MILITARY SPECIFICATION SHEET

LOUDSPEAKER, PERMANENT MAGNET (ENCASED, 2-WATT, FUNGUS-,
GUNBLAST-, AND IMERSSION-RESISTANT), TYPE LS-590()/U

MIL-L-12632/1A
AMENDMENT 1

FIGURE 3. Audio transformer

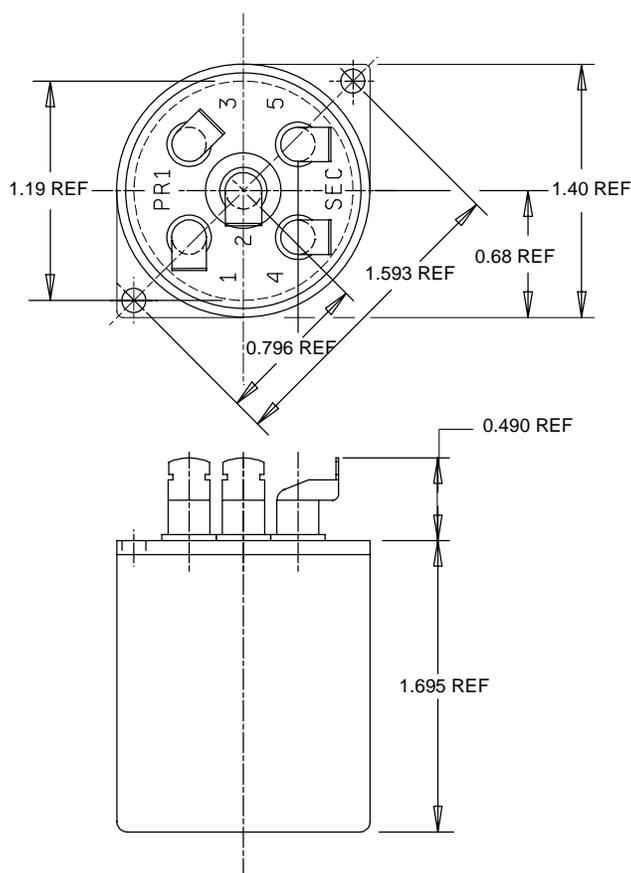
PAGE 3: FIGURE 3: Delete and substitute :

Audio transformer: Delete and substitute the following:

“Audio transformer - Type TF4R21YY of MIL-T-27/1 (P/N M27/1-01) in accordance with MIL-T-27 (see figure 3).”
